## *City of El Paso – City Plan Commission Staff Report*

**Case No:** SUSC13-00008 Montecillo Unit Four  
**Application Type:** Major Preliminary  
**CPC Hearing Date:** December 5, 2013  
**Staff Planner:** Alejandro Palma, (915) 541-4482, [palmaaj@elpasotexas.gov](mailto:palmaaj@elpasotexas.gov)  
**Location:** East of Mesa and North of Argonaut  
**Acreage:** 25.451 acres  
**Rep District:** 8  
**Existing Use:** Vacant  
**Existing Zoning:** SCZ (Smartcode; T4, T4O)  
**Proposed Zoning:** SCZ (Smartcode; T4, T4O)  
**Nearest Park:** within subdivision  
**Nearest School:** Morehead Middle School (.72 mile)  
**Park Fees Required:** N/A  
**Impact Fee Area:** N/A  
**Property Owner:** EPT Mesa Development East, L.P.  
**Applicant:** EPT Mesa Development East, L.P.  
**Representative:** Conde, Inc.

The applicant proposes to subdivide 25.451 acres of vacant land. Sixty-Four mixed-use lots, a .781 acre park “Green with Playground, a .189 civic space “Promontory with Play Structures” are all proposed within this subdivision. Primary access to the subdivision is proposed from Montecillo Boulevard. This application is being reviewed under Title 21 (SmartCode) and does comply with th

# ATTACHMENT 3

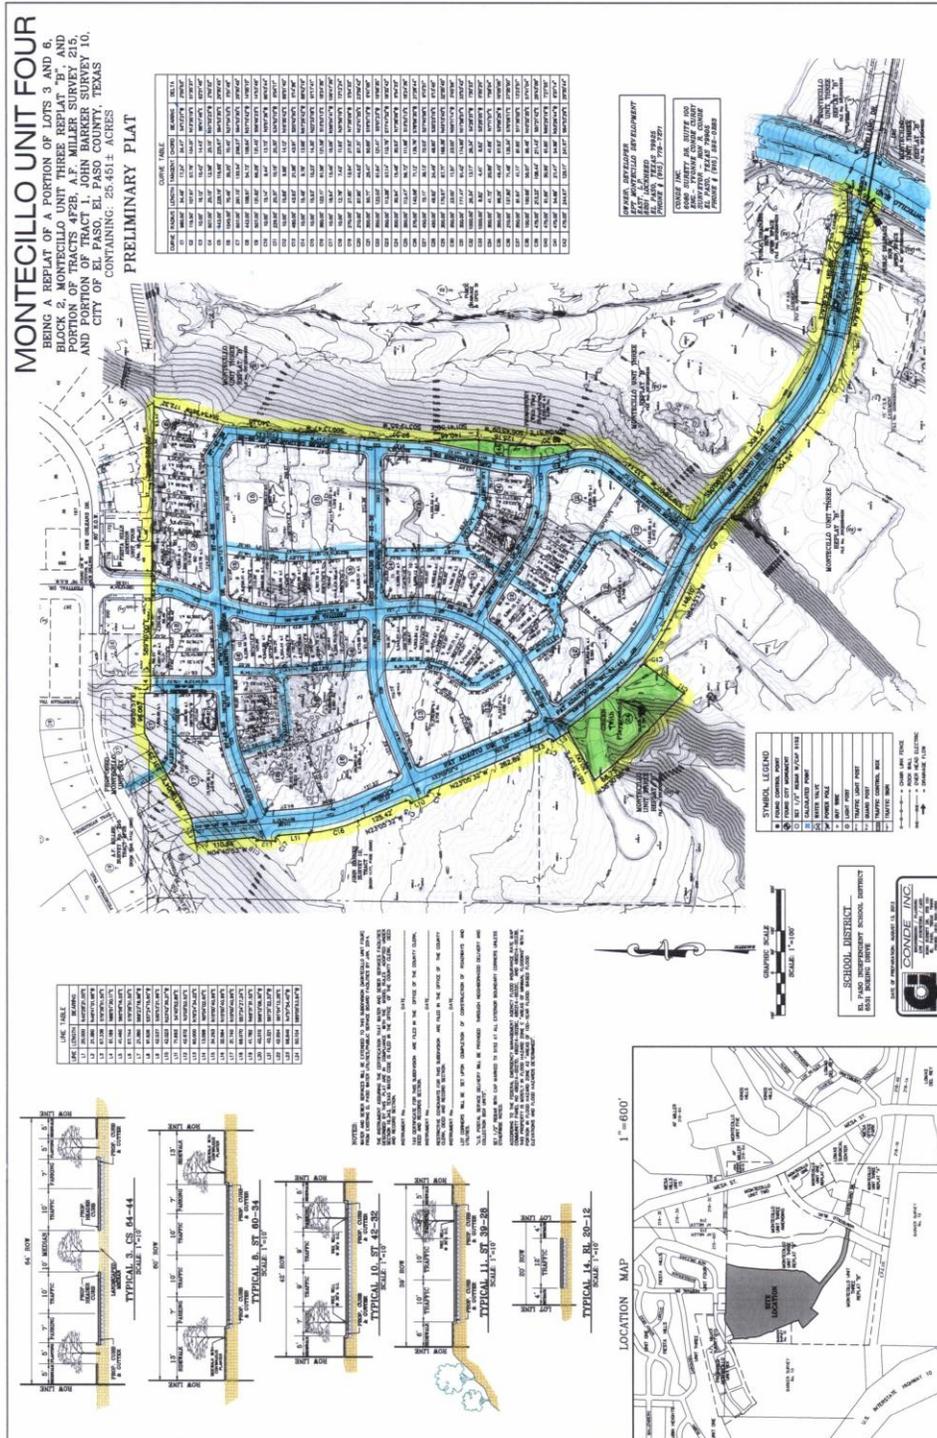
- In accordance with Section 19.15.070.A (Intersections, half-streets), all street intersections shall be situated at an angle of ninety degrees, plus or minus fifteen degrees and must maintain intersection visibility as determined by the latest edition of AASHTO's "A policy on Geometric Design of Highways and Streets." (**Visibility cannot be determined until submittal of the improvement plans.**)

1. Show existing and proposed drainage flow patterns on the preliminary plat. Identify the discharge location for all stormwater runoff.
2. Show runoff direction arrows on Street Sections and verify tree placement illustrations.

1. Lot 1, block 24 noted as "Green" (per Smart Code definitions):
  - a. This parcel is to be developed as a "typical" park with sod and irrigation system;
  - b. A 4'- 6' high combination rock wall/wrought iron safety fence be introduced along the rear steep slopes due safety concerns.
2. A "Terminated Vista" needs to be provided at the intersection of Pat Aauto Dr. & Carlos Gallinar Dr.
3. Promontory area - Lot 1, Block 14A:
  - a) Parks requests that during the playground area design, a 4'- 6' high safety fence be introduced all along the entire boundary line due to the close proximity of the proposed playground area to the street and the hazards of the road traffic to prevent a child from inadvertently running into the traffic or steep slopes (nearby hazards) as per The Consumer Product Safety Commission (CPSC) standards.

4. All sloped areas shall be cleaned and free of trash & all manmade slopes /disturbed areas shall be re-vegetated with desert plants complete with drip / irrigation system.
